**MINUTES OF THE PLANNING AUTHORITY MEETING
OF THE BRIGHTON COUNCIL, HELD IN THE COUNCIL CHAMBERS,
COUNCIL OFFICES, 1 TIVOLI ROAD, OLD BEACH
AT 5.50P.M. ON TUESDAY, 2 SEPTEMBER 2025**

7.1 Planning Scheme Amendment to the Brighton Local Provision Schedule - RZ 2025/004 - Boyer Road Precinct Structure Plan Area - Section 40K Report

Type of Report:	Section 40K of <i>Land Use Planning and Approvals Act 1993</i>
File Reference:	RZ 2025-004
Requested by:	Brighton Council Officers
Owner:	Various
Location:	50 Boyer Road 170 Boyer Road 182 Boyer Road 25 Cobbs Hill Road 29 Cobbs Hill Road 31 Cobbs Hill Road
Proposal:	A. Amend the planning scheme maps to: a. Rezone the land at: i. 50 Boyer Road, 170 Boyer Road, 182 Boyer Road and parts of 25 Cobbs Hill Road, 29 Cobbs Hill Road and 31 Cobbs Hill Road from Future Urban Zone to General Residential Zone ii. Part of 31 Cobbs Hill Road from Future Urban Zone to Landscape Conservation Zone b. Amend the Priority Vegetation Area Overlay on 31 Cobbs Hill Road and 25 Cobbs Hill Road, Bridgewater c. Amend the Local Heritage Place BRI-C6.168 overlay mapping at 50 Boyer Road, Bridgewater d. Insert the Local Area Objective overlay on part of 50 Boyer Road

Figure 2. Aerial image showing the recommended amendment to the THR registered boundaries of the Genappe property and the Protection Zone for the Red Brick feature

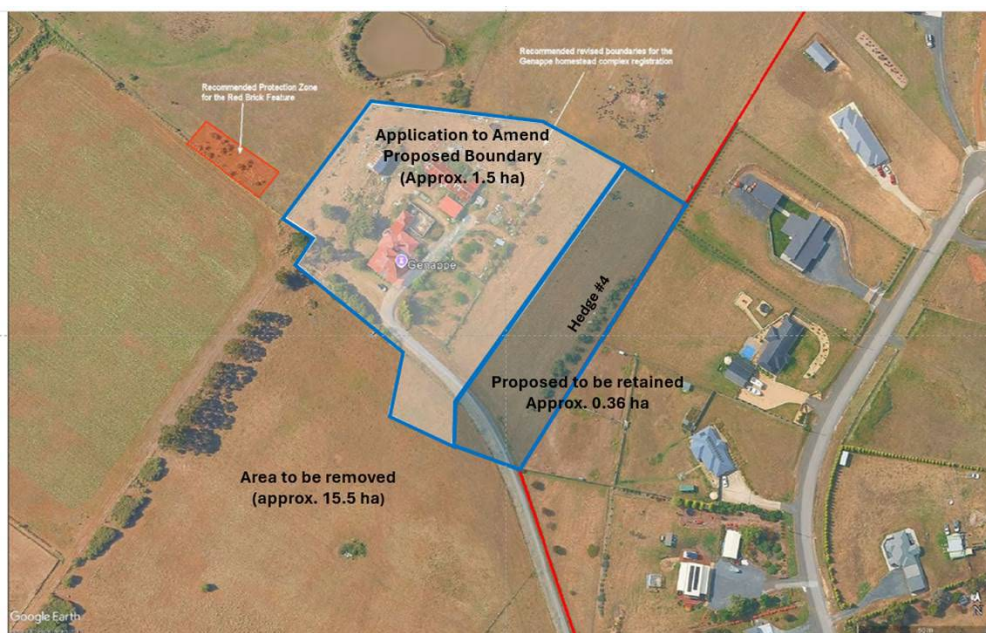
Table 2 outlines the feedback received from Heritage Tasmania, which included a request for clarification regarding the proposed boundaries of the future listing.

Feedback Summary	Response
The significance of hedgerows in the historic rural landscape is noted in the Historic Heritage Assessment, although it is noted that Hedgerow 3 will need to be removed, as will parts of the other hedges, to accommodate the proposed development. The Heritage Council have recently been under pressure from members of the public to protect these remnant landscape features which are impacted by development pressure, the identification of a fourth hedge at Genappe which will not be directly impacted by the proposed development represents an opportunity to preserve a small remnant of the historic landscape which we suggest should be pursued.	To ensure the long-term protection of Hedgerow 4, the proposed amendment to the heritage listing for Genappe has been expanded to include an additional 0.36 hectares of land (refer to Figure 2).
